Freeport-McMoRan Cobre Mining Company
P.O. Box 10
Bayard, NM 88023

April 10, 2017

Re: Freeport-McMoRan Cobre Mining Company –
GR002RE Revision 15-1, Response to Agency and Public Review Comments

Figure 1 Conceptual Model of the Open Pit Lake

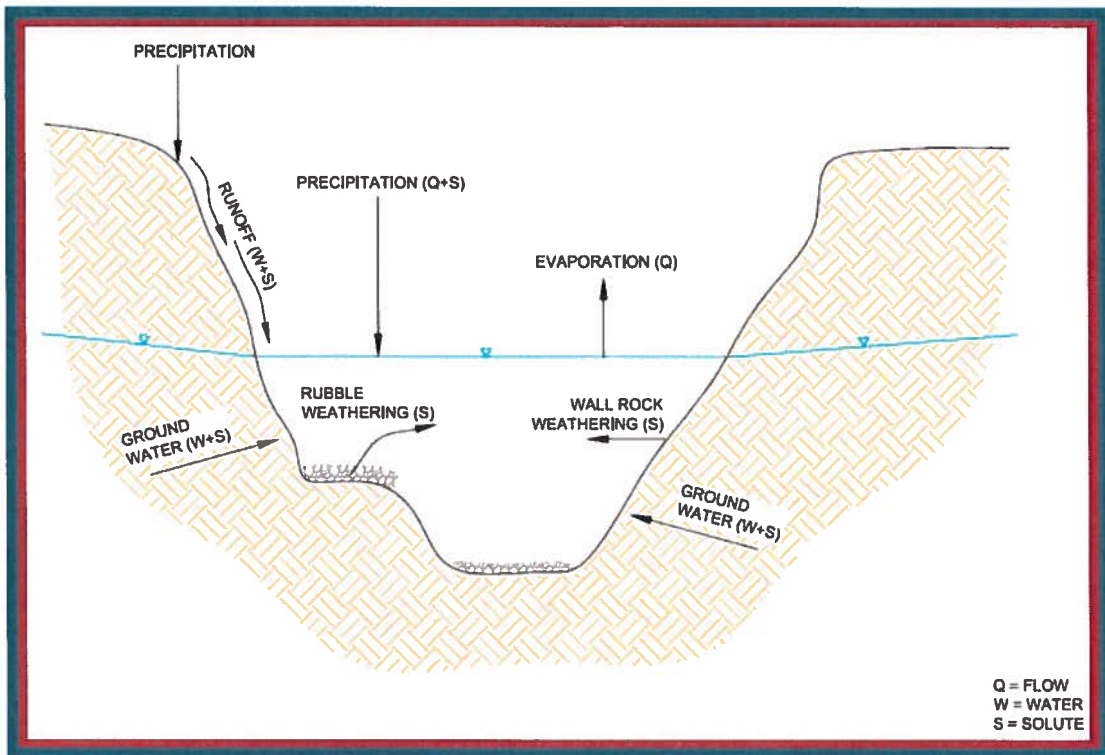
Page 5, Section 1.3.3, 2nd bulleted item. Continental Pit a Hydrologic Sink. The Updated CCP indicates that the Continental Pit will function as an evaporative sink. Stage 1 Abatement Plan (2005), and Stage 1 Abatement Report (2011) plus an updated groundwater study in 2008 by Telesto identified the Continental Pit as a hydrologic sink. The 2008 study constructed a 37-layer groundwater flow model with 12 material properties for geologic units or structures. Overall, the Updated CCP may overstate the evaporation associated with pit lake and Barringer fault as a barrier to flow. Based on the results of the groundwater flow model and depiction of potentiometric surface, the conceptual model may need some reconsideration and clarification. Specifically, the following points are made from reviewing portions of supporting documents for Updated CCP:

The hydrologic predictions in the pit lake modeling were performed using a water balance approach where all of the inputs (i.e., groundwater inflow, precipitation, runoff) minus all of the outputs (i.e., evaporation, groundwater outflow-when present) equals the change in storage. Two general scenarios were considered: 1) pit lakes with no backfill and 2) pit lakes with backfill. Figure 1 (Telesto, 2008b) summarizes the inputs and outputs from the no-backfill scenarios. As shown in Figure 1, the evaporation component should be the lake evaporation (total evaporation) as the precipitation is counted as an input term. Utilizing the net evaporation, as the commentor suggests, would be double counting precipitation input and would be incorrect.
